NOTICE OF DECISION

Administrative Site Development Permit and Lot Line Adjustment

McFadyen Townhomes 683 NW Locust Street

Applications Project No. PRJ18-00032

PLANTING PLAN

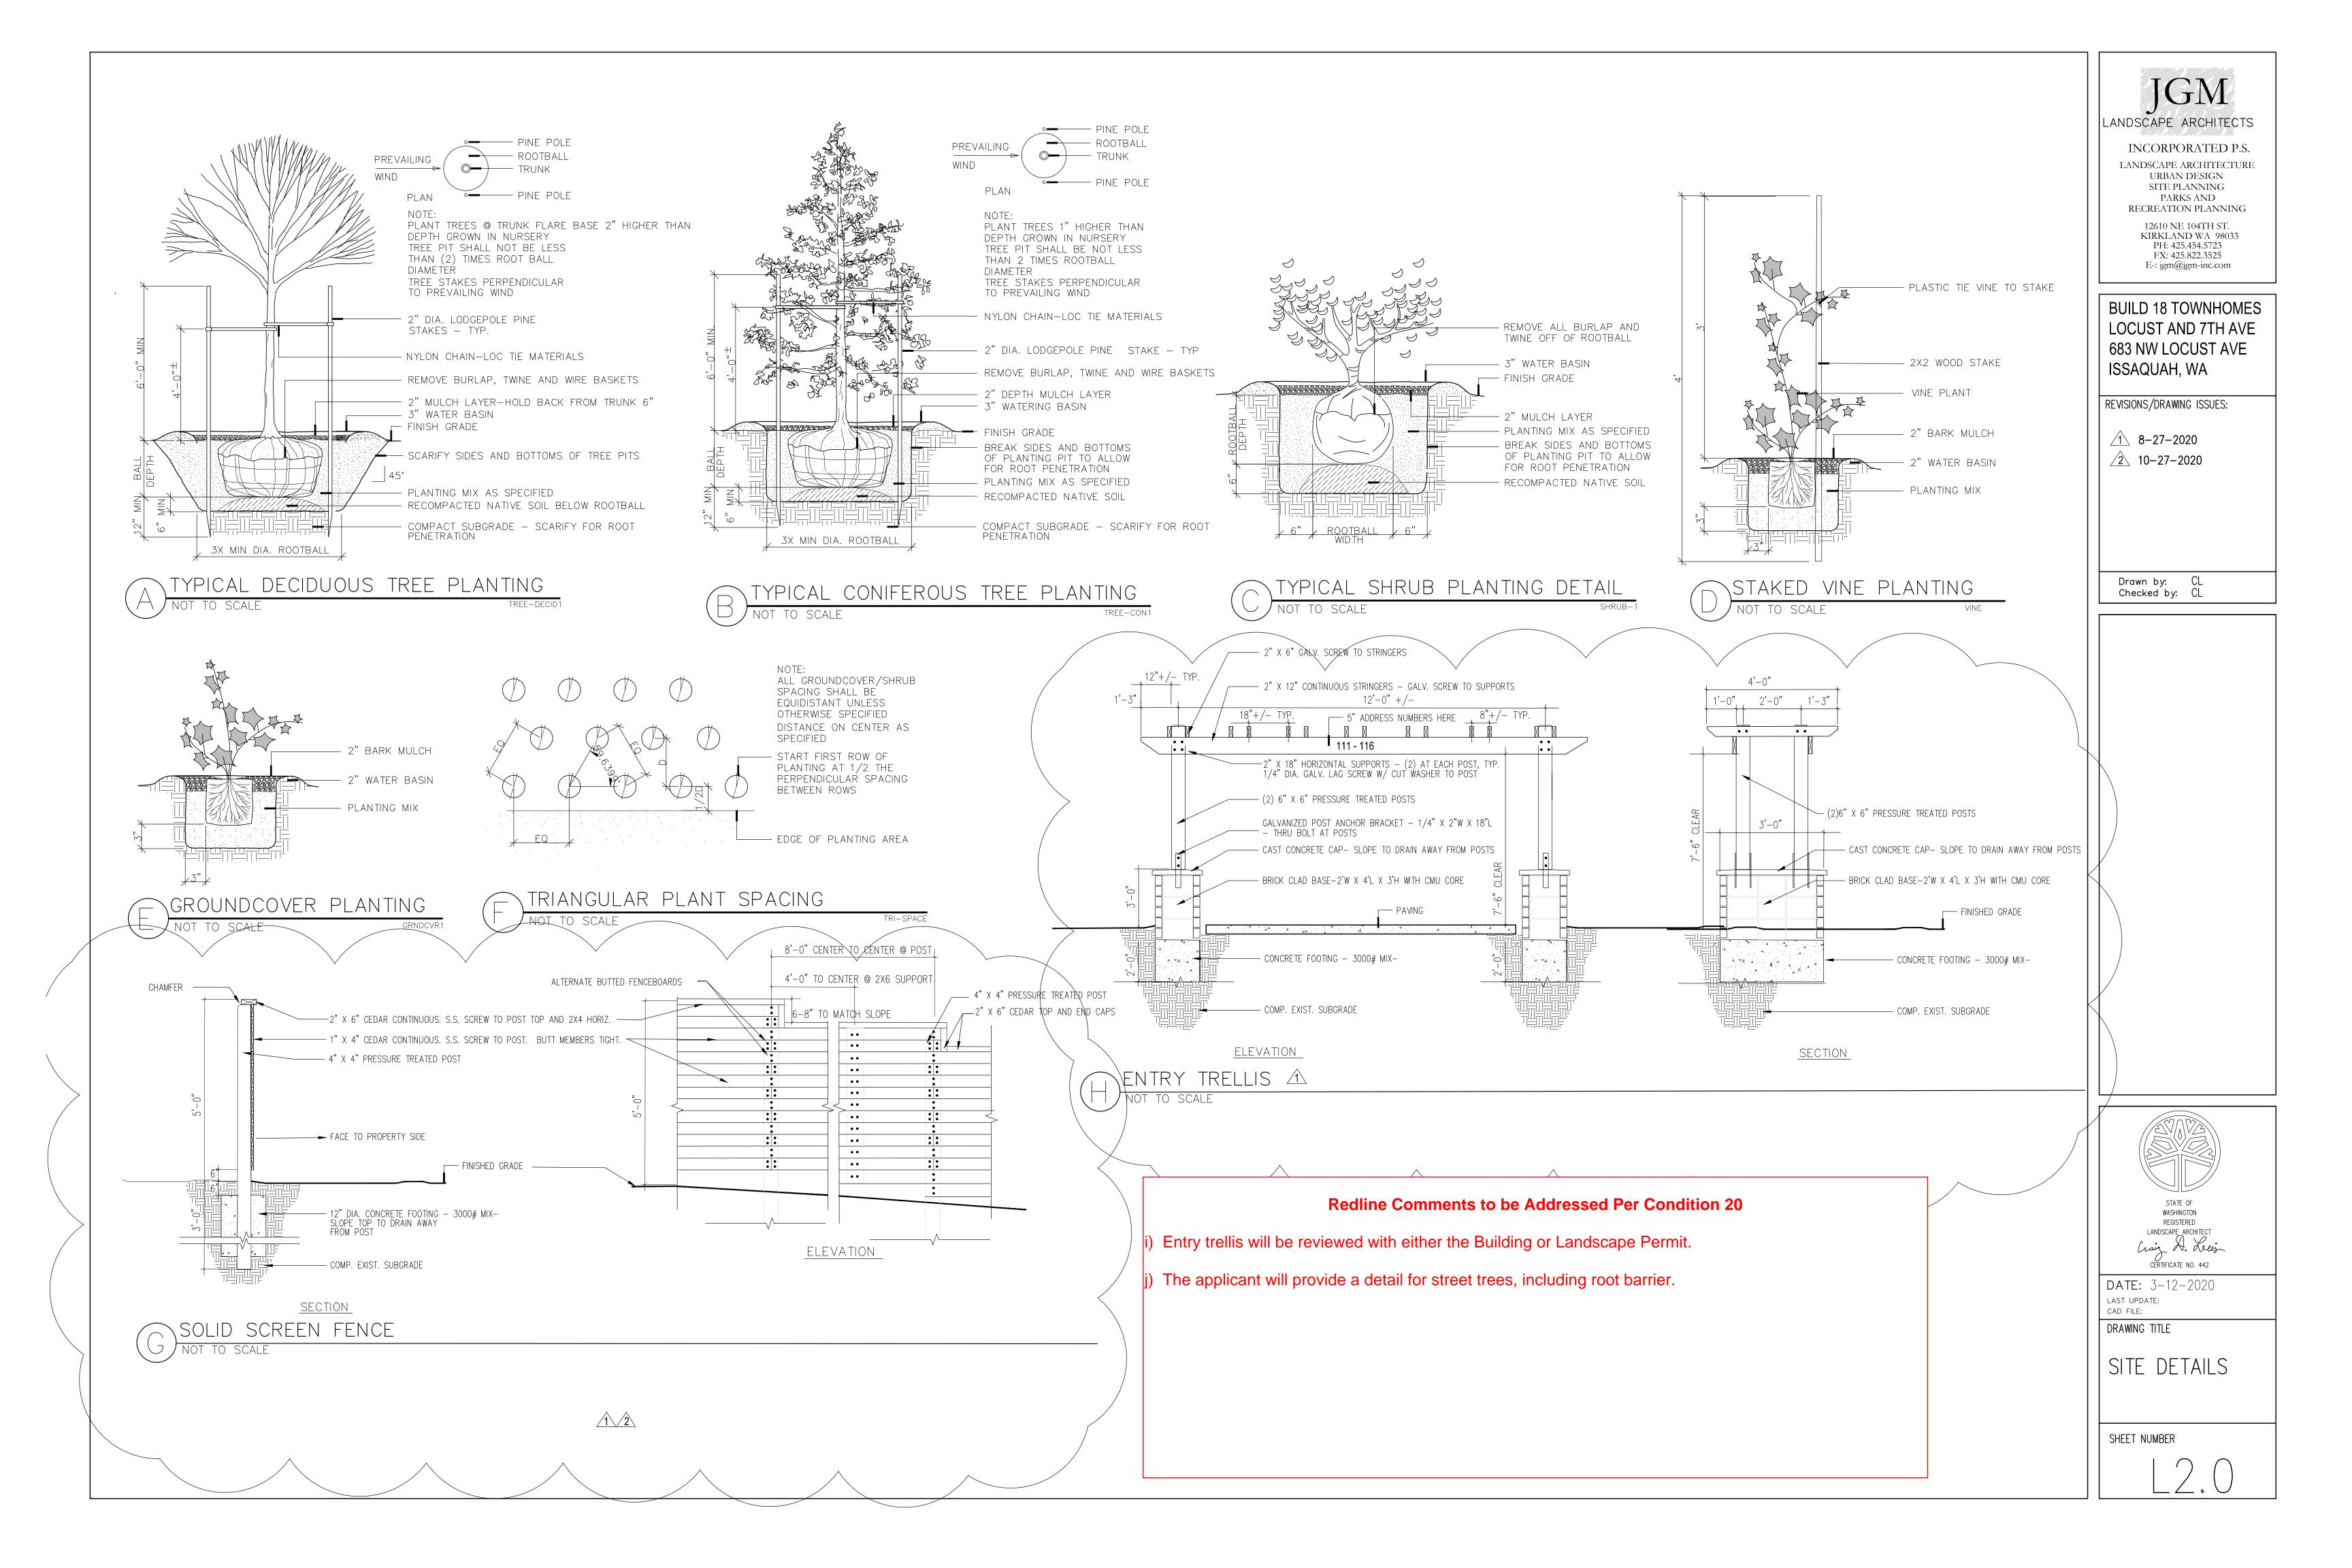
Redline Comments t	be Addressed	Per Condition 20
--------------------	--------------	-------------------------

- d) Serviceberry may only be used under special circumstances, such as under very low power lines. The applicant will propose a different street tree.
- e) Per the Master Street Tree plan, Quercus robur, Fastigiata is the specified tree for NW Locust Street.
- f) Per the Master Street Tree plan, Liquidamber Styracafolia is the specified tree 7th Avenue NW.
- g) Western Red Cedar is a tree capable of growing to 30 feet in diameter. The applicant will propose a different species more appropriate for the planter size.
- h) With the landscape permit, all vegetation must be depicted at 85% of mature size.
